Project	IEEE 802.16 Broadband Wireless Access Working Group < http://ieee802.org/16 >	
Title	Preamble, FCH and MAPs Transmission in Transparent Relay Station	
Date Submitted	2007-03-06	
Source(s)	Young-jae Kim, Kyu Ha Lee, Jae Hyung Eom, Changkyoon Kim Samsung Thales San 14, Nongseo-Dong, Giheung-Gu, Yongin, Gyeonggi-Do, Korea 449-712	Voice: +82-31-280-9975 Fax: +82-31-280-1562 youngjae2.kim@samsung.com kyuha.lee@samsung.com
	Byung-Jae Kwak, Su Chang Chae, Young-il Kim ETRI 161, Gajeong-Dong, Yuseong-Gu, Daejeon, Korea 205-350	Voice: +82-42-860-6618 Fax: +82-42-861-1966 bjkwak@etri.re.kr
Re:	Call for Technical Proposal regarding IEEE Project P802.16j	
Abstract	The document contains technical proposals for IEEE P802.16j that provides a frame structure.	
Purpose	This is a response to Call for Technical Proposals regarding IEEE Project P802.16j.	
Notice	This document has been prepared to assist IEEE 802.16. It is offered as a basis for discussion and is not binding on the contributing individual(s) or organization(s). The material in this document is subject to change in form and content after further study. The contributor(s) reserve(s) the right to add, amend or withdraw material co

Figure xxx. Example of configuration for a transparent relay frame structure

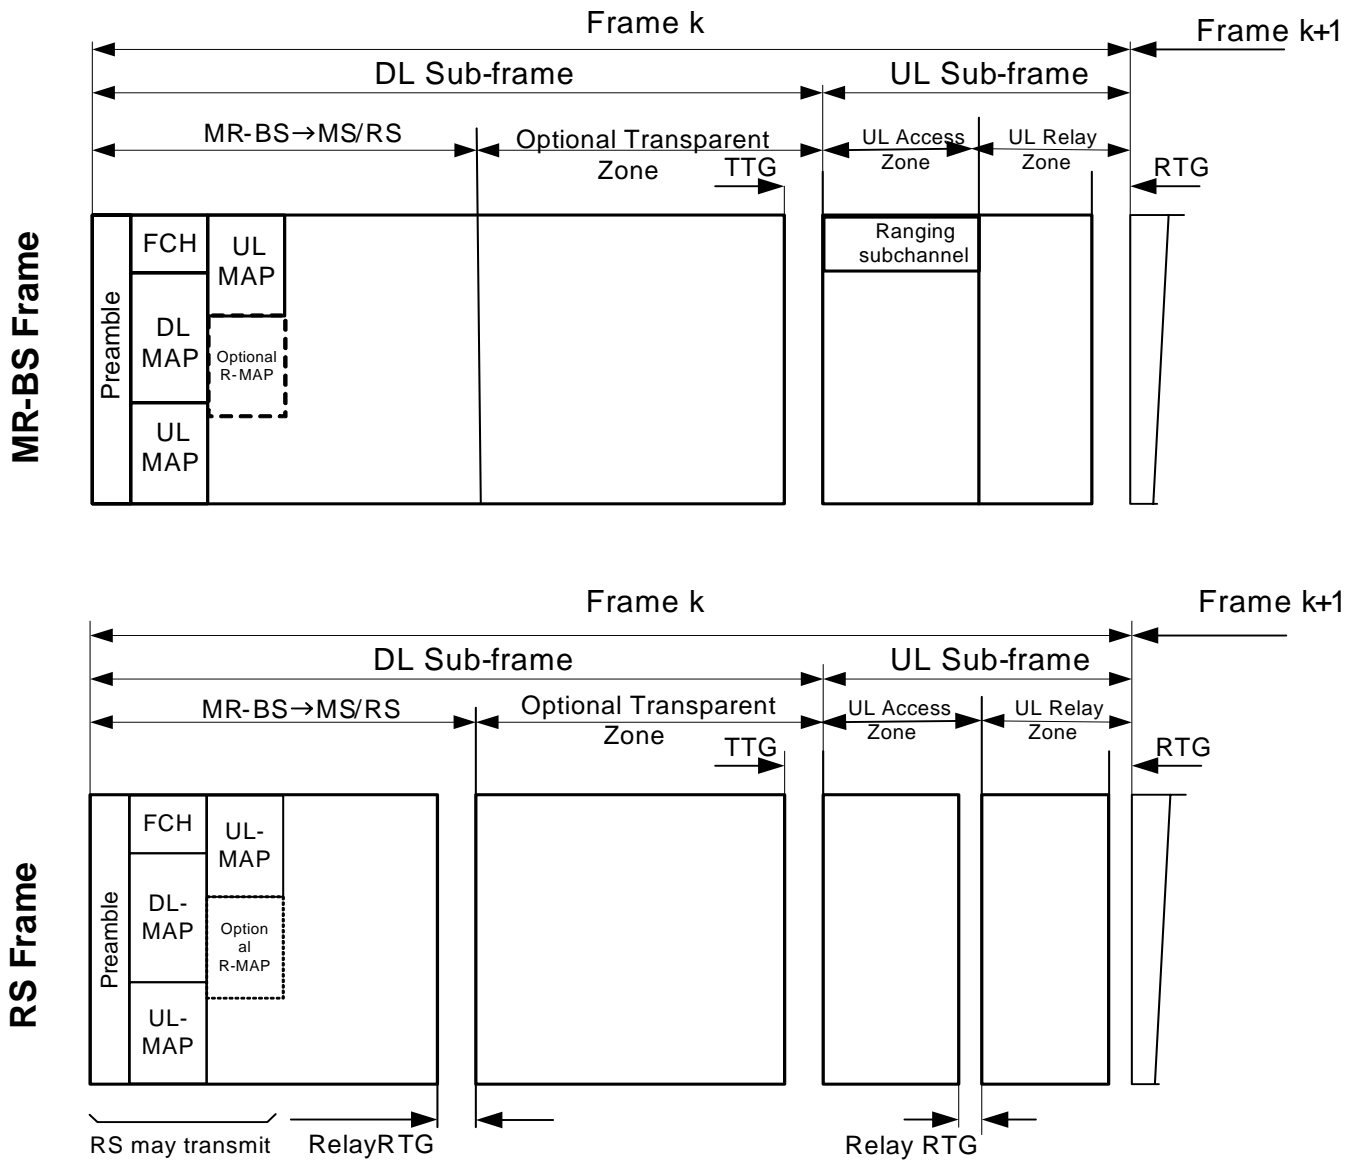
[Replace Figure xxx at section 8.4.4.7.1.1]
